Modification of the shielded beam screen design & misalignment analysis

HL-LHC TCC, 8th March 2018

REFERENCE : LHC-VSM-EC-0001

HL – LHC Engineering Change Request Modification of the shielded beam screen design

Main modifications of the Q1 beam screen

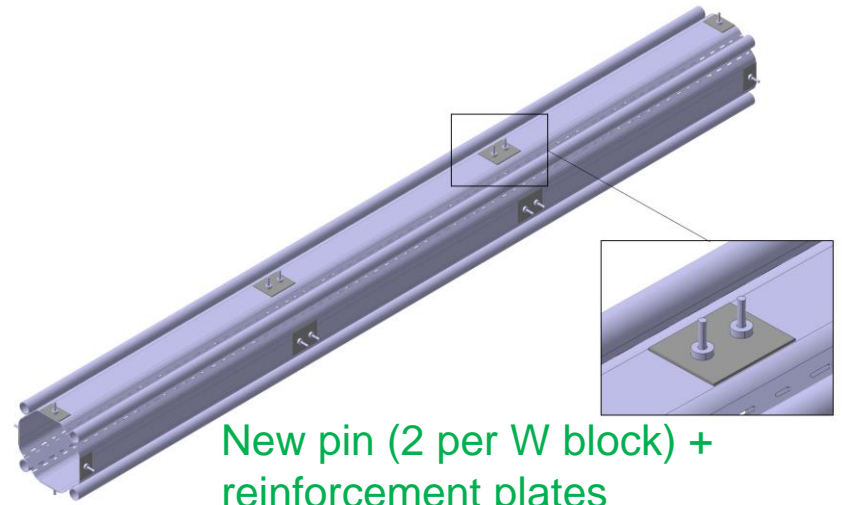
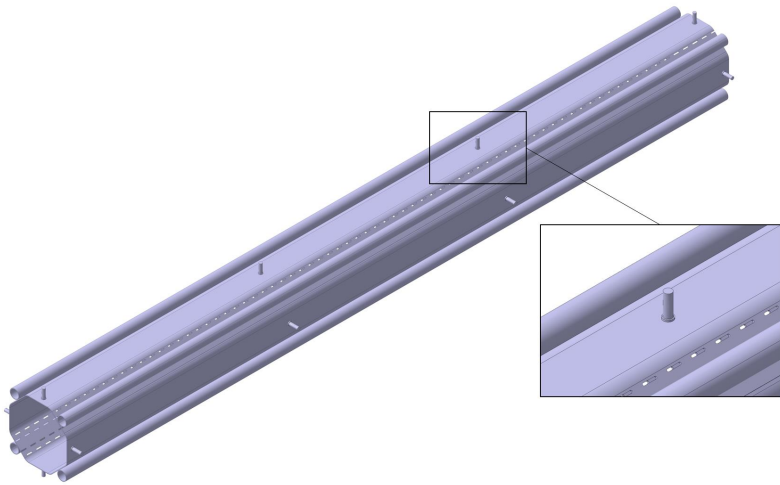
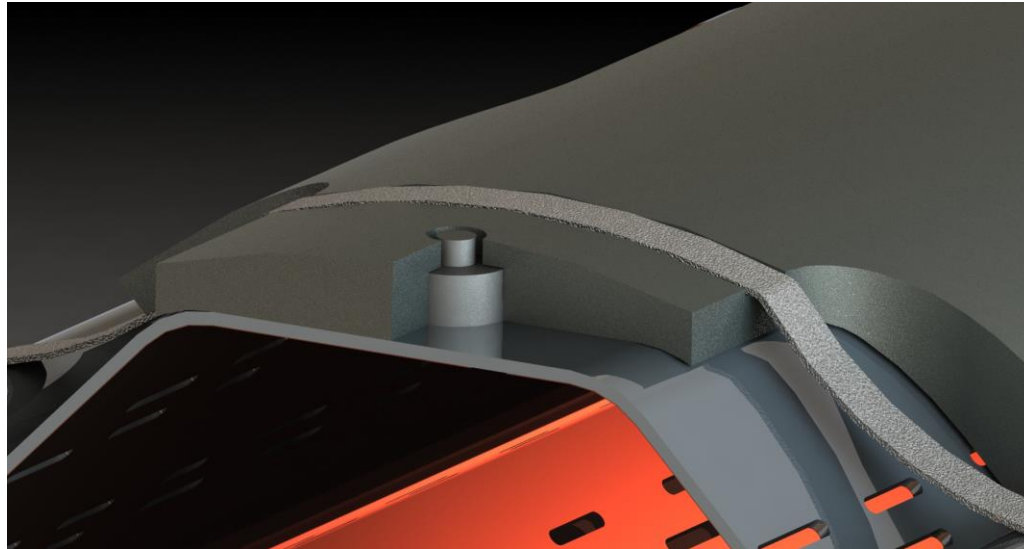
Old design

New design

New pin (2 per W block) + reinforcement plates

Main modifications of the Q2x-Q3-D1 beam screens

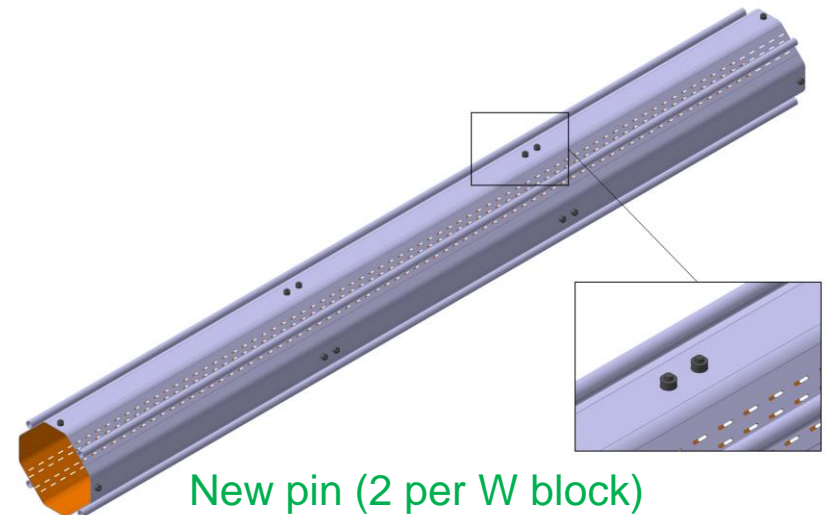
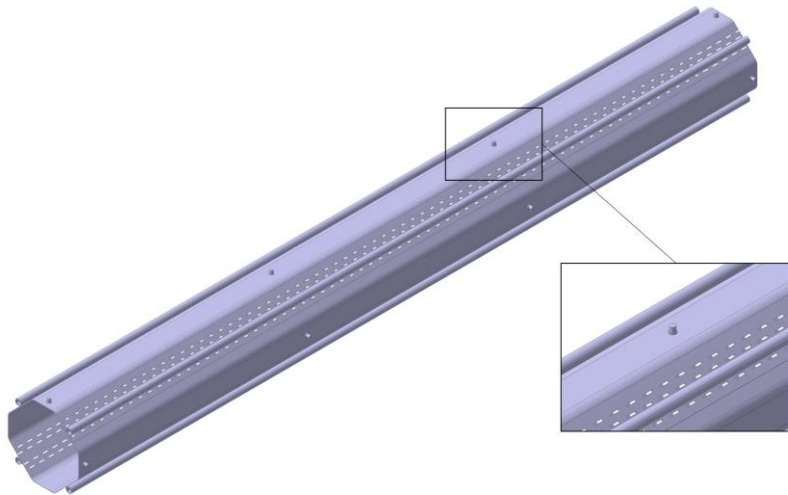
Old design

New design

New pin (2 per W block)

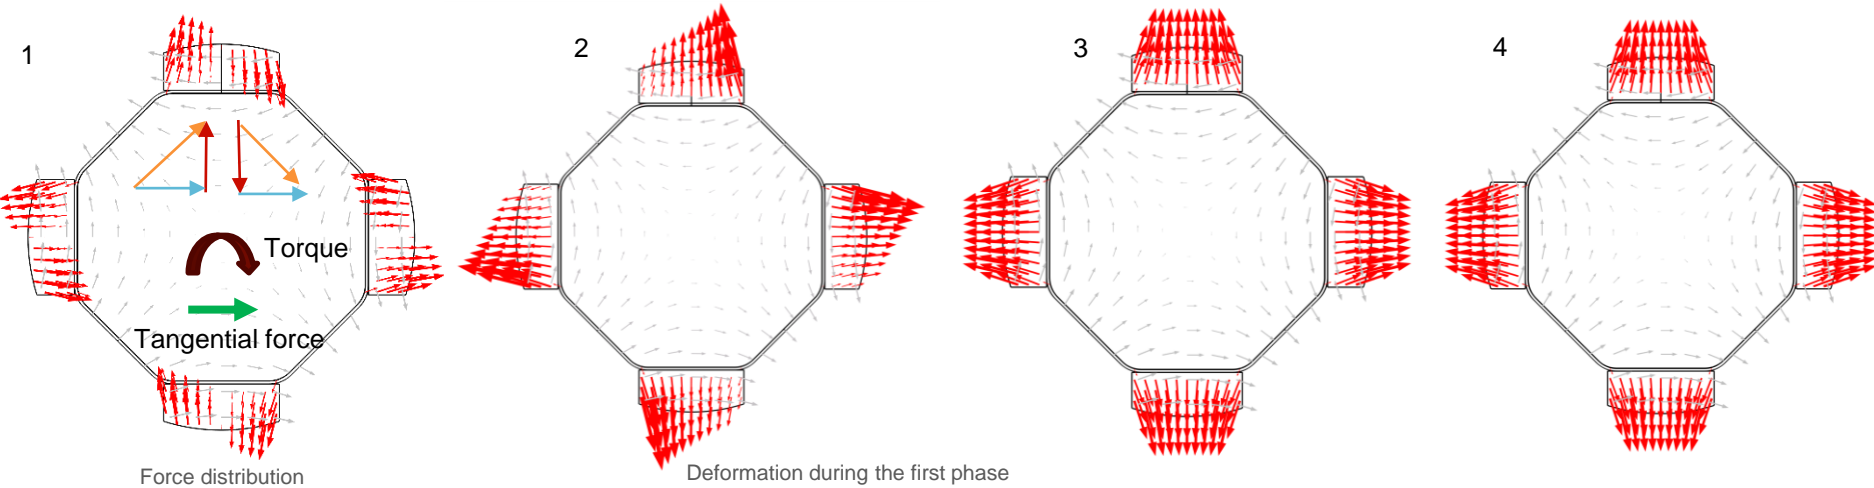
A new quench protection system, called CLIQ [1], has been proposed for the triplet quadrupoles. It is based on a fast transient alternative current unbalanced between the different coils of the magnet. This fast alternative current induces dissipation and temperature increase in the superconductor and then leads to the resistive transition. The fact that the current evolution is not anymore monotonic leads to an inversion of the Lorentz force direction (forces pointing toward the aperture center for a current increase). In addition, during this transient, the current evolution is different in two adjacent coils: one is subjected to a current decay leading to forces pointing to the cold bore whereas a current increase occurs in the other one leading to forces toward the aperture center. For the beam screen and in particular for the tungsten blocks, this leads to torques of 700 N.m and 580 N.m, per beam screen meter, for the absorbers and beam screen tube, respectively (Fig. 2). In case of magnet quench with the CLIQ protection system, the pins are not anymore only positioning elements but are structural components subjected to mechanical forces and torques. The design of the beam screen with positioning pins is not compatible with the CLIQ discharge (high stresses and plastic deformation in the pin areas).

Impact of CLIQ

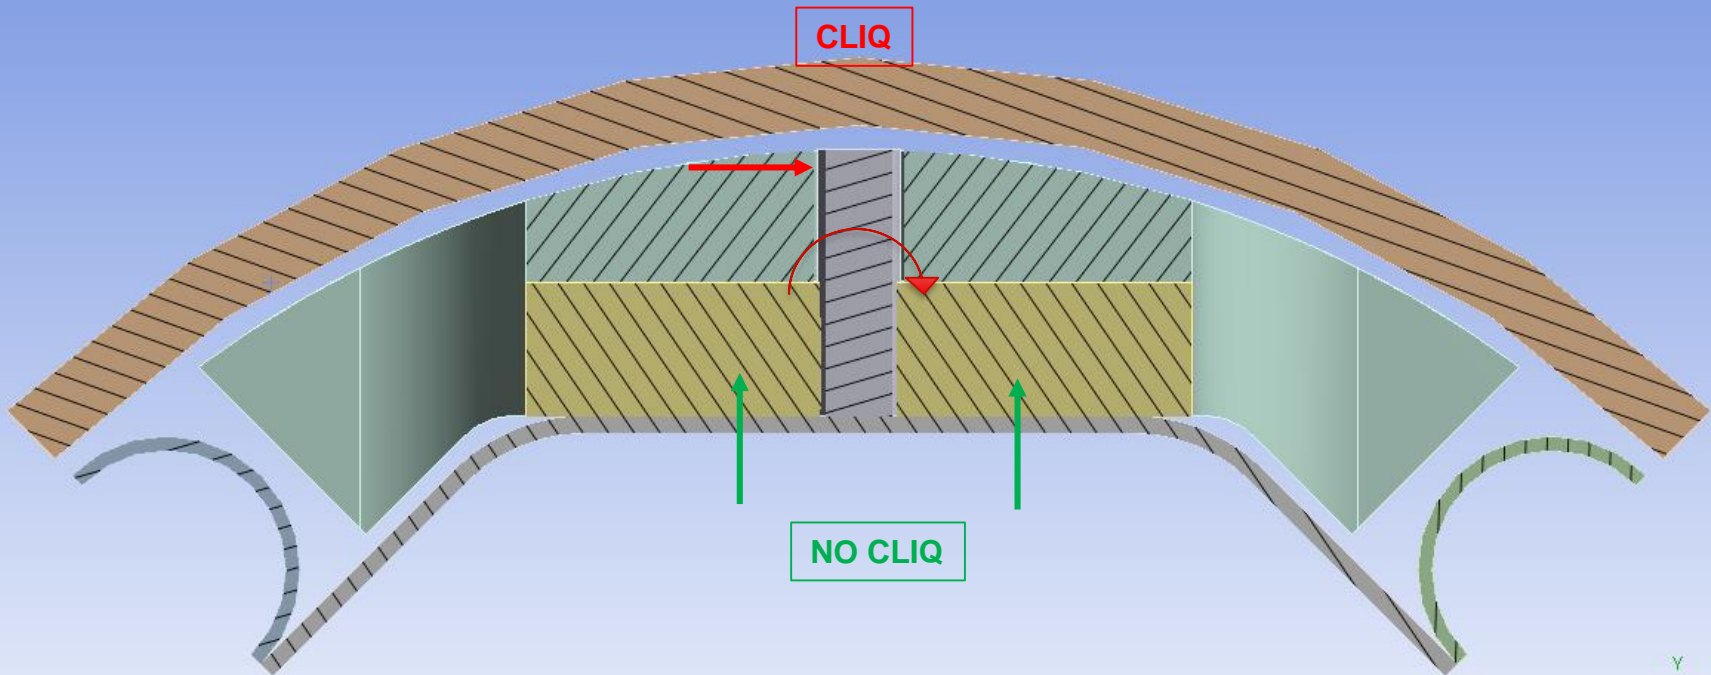
The pin becomes a structural component!
→ New solution needs to be found!

Proposed solution

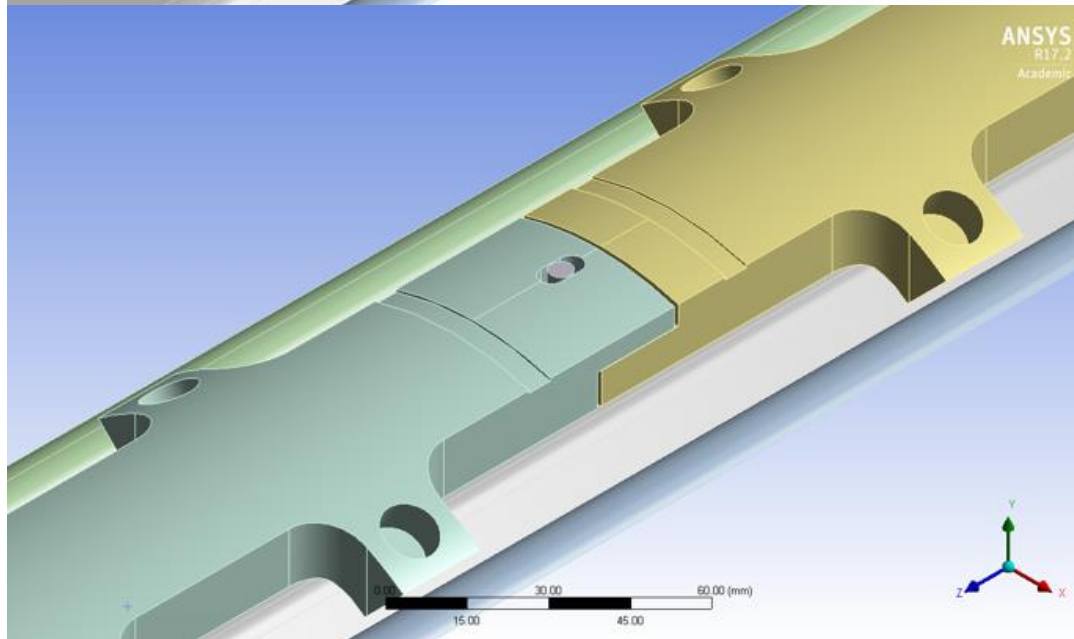
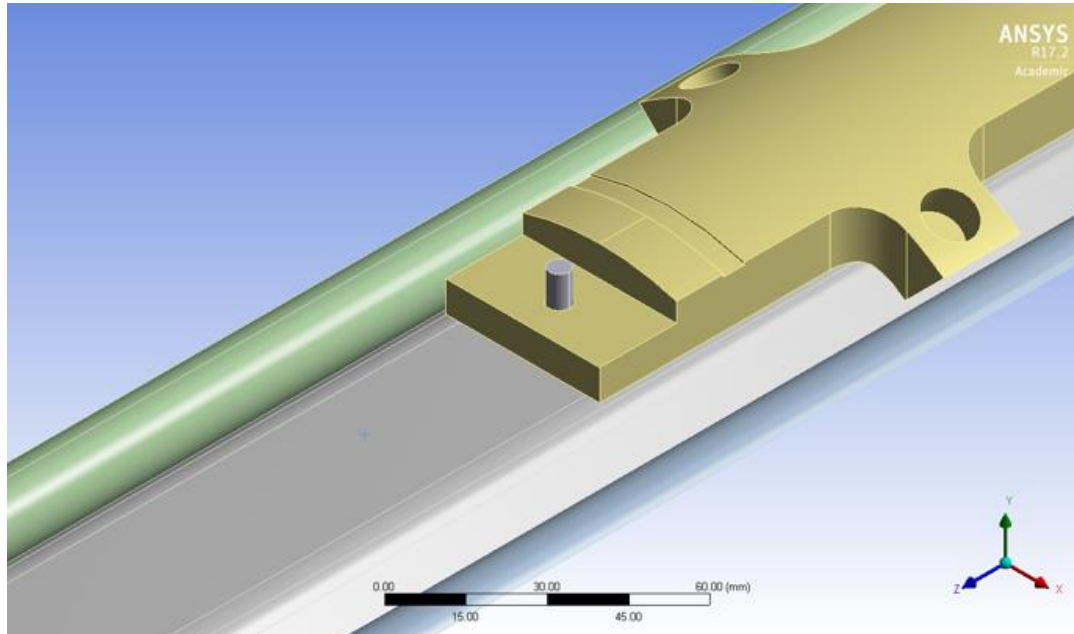
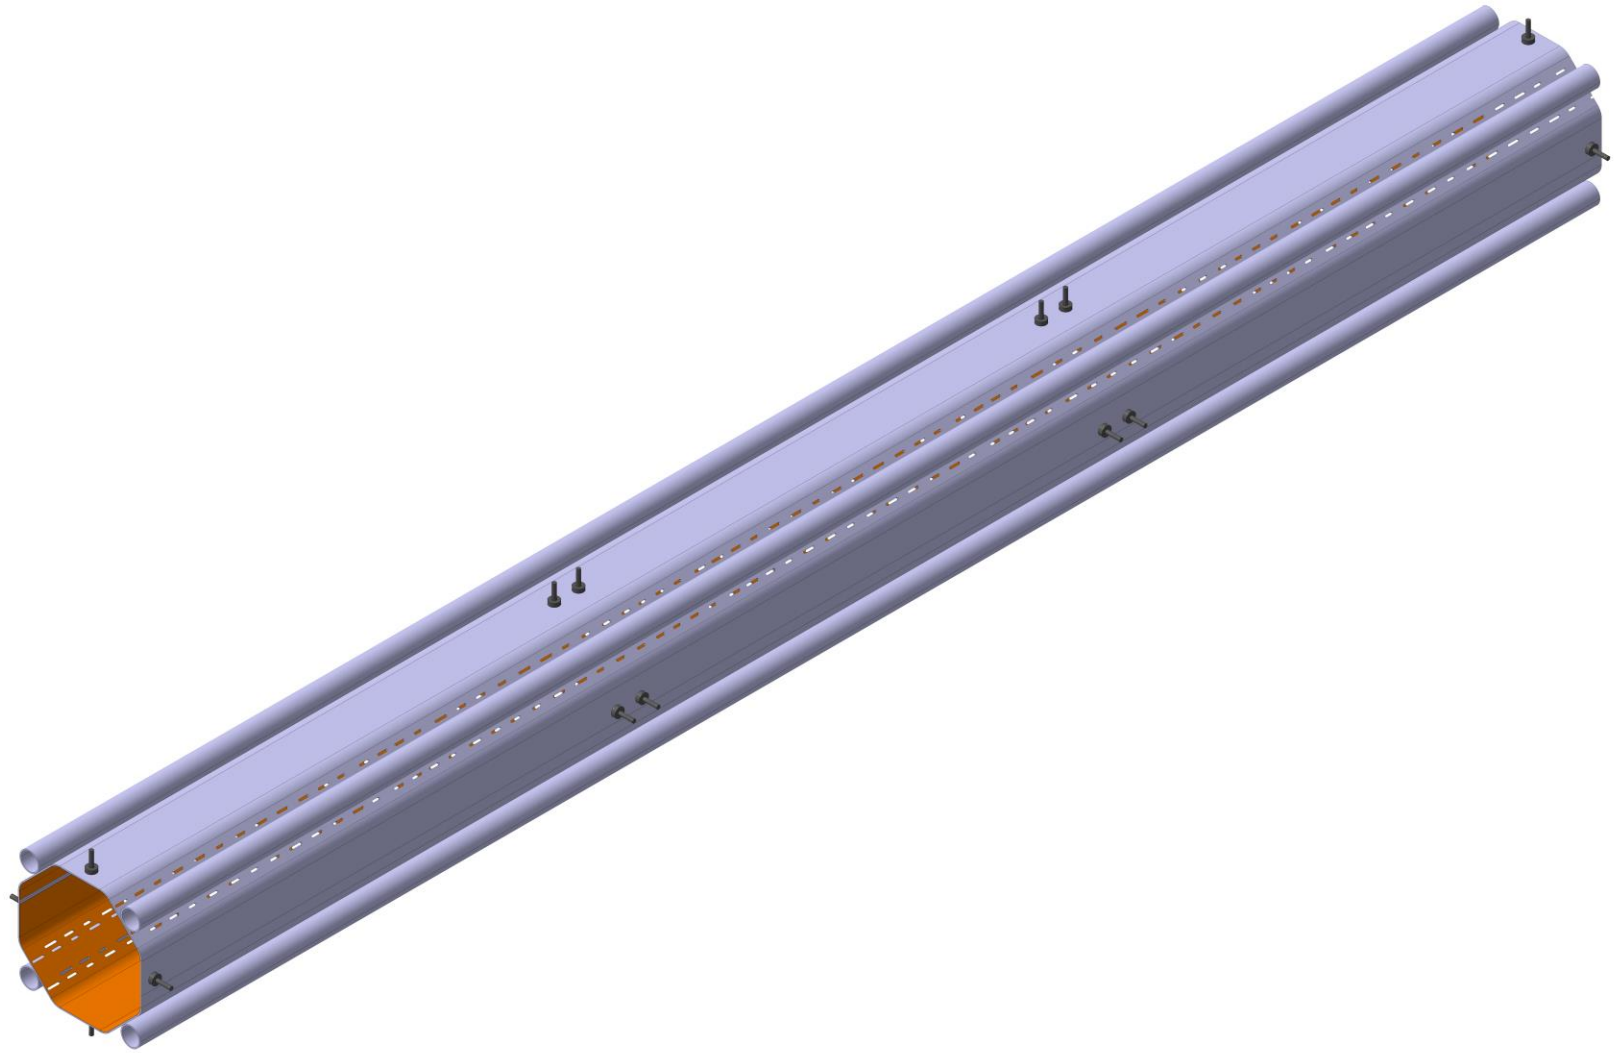
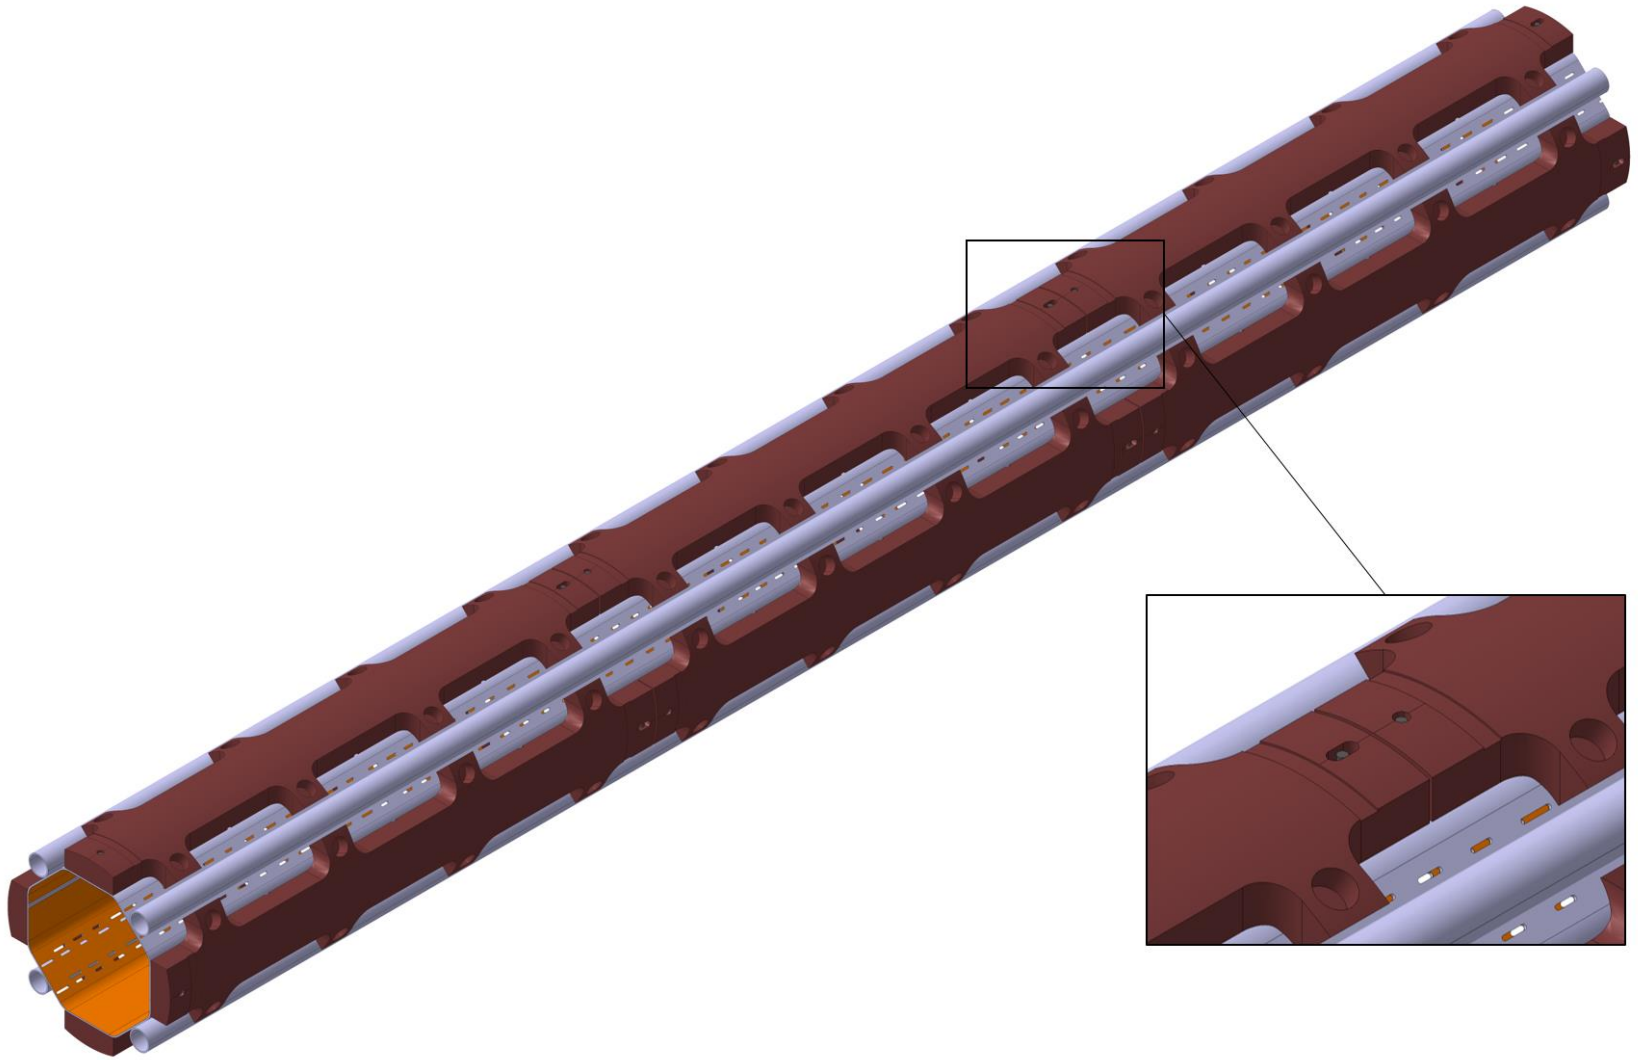
Old pins

Old W blocks

New pins

New W blocks
